INTERNATIONAL ORGANIZATION OF MOTOR VEHICLE MANUFACTURERS

R-point and manufacturer design seat back angle

Informal group gtr head restraints

Example of Driving Posture Comparison between Design seat back angle and 25 degree seat back angle

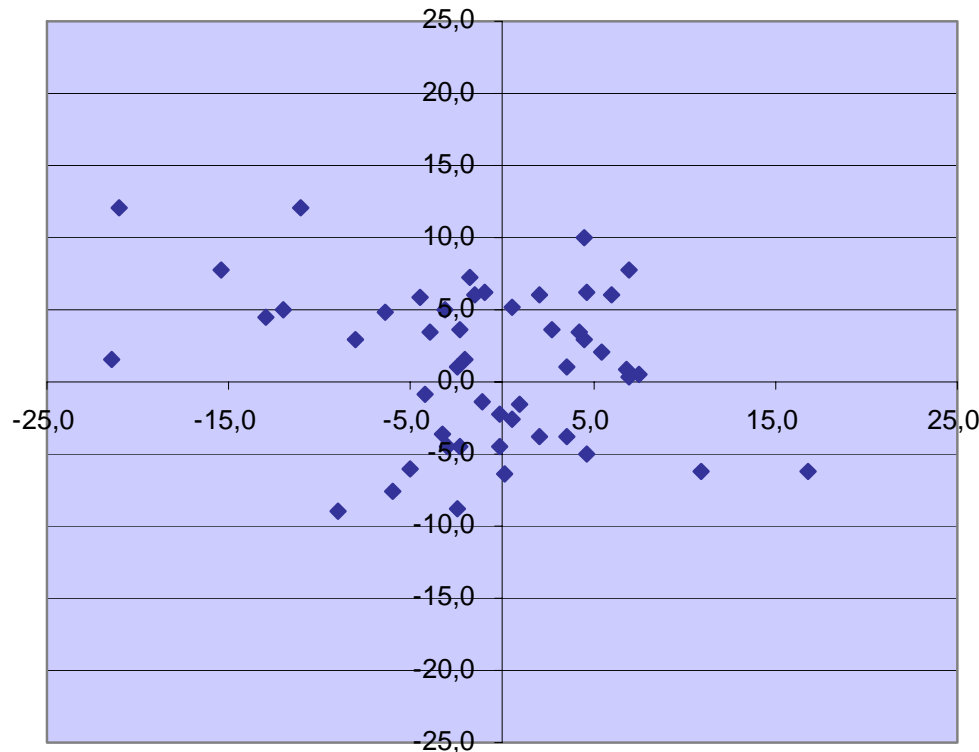
In case of typical truck, 25 degree seat back angle makes unusual driving posture.

- Design seat back angle
15 degree

- FMVSS202a proposal
25 degree

Relationship H / R-point

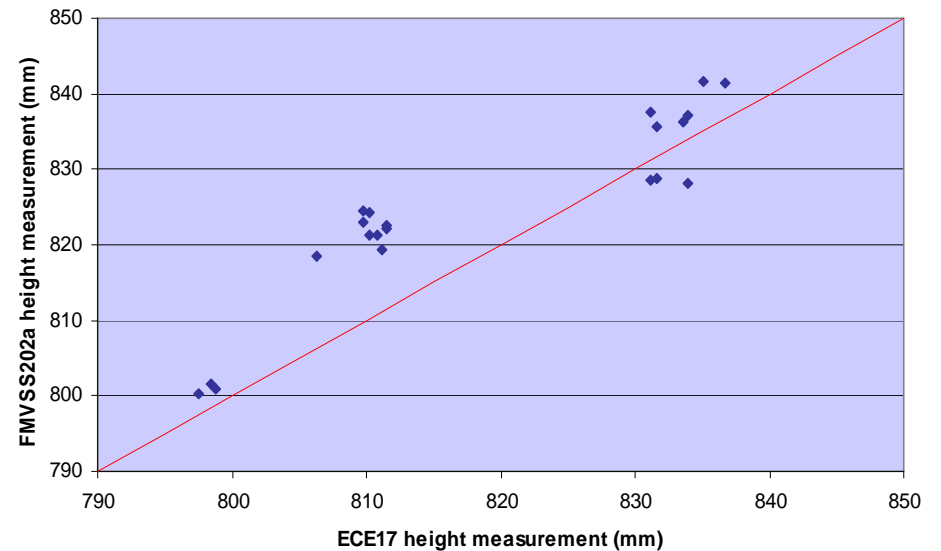
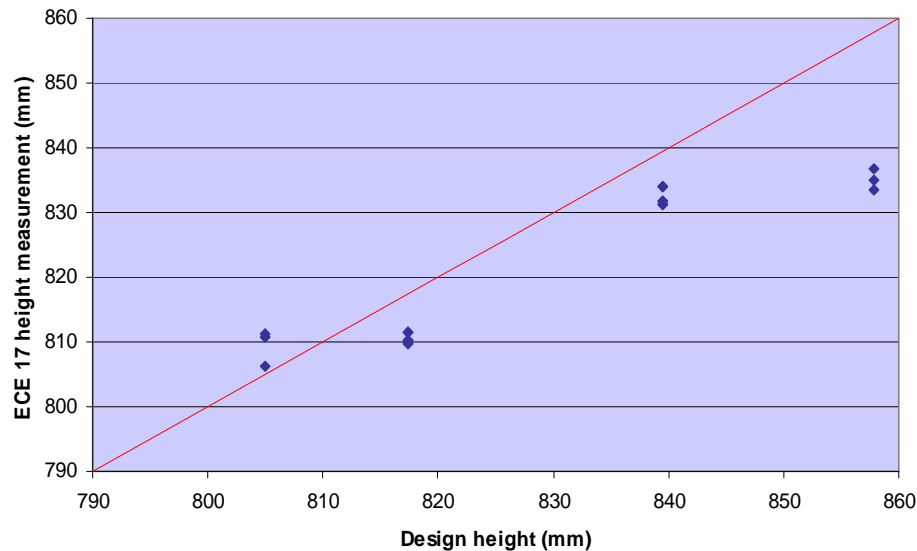
- Data used from HR-5-14 presented by Canada in Jan 2006
- ECE17 measurement underestimates the design height
- FMVSS202a measurement gives a height above the ECE17 measurement
- Conclusion: ECE17 is the worst case (measures the lowest height)
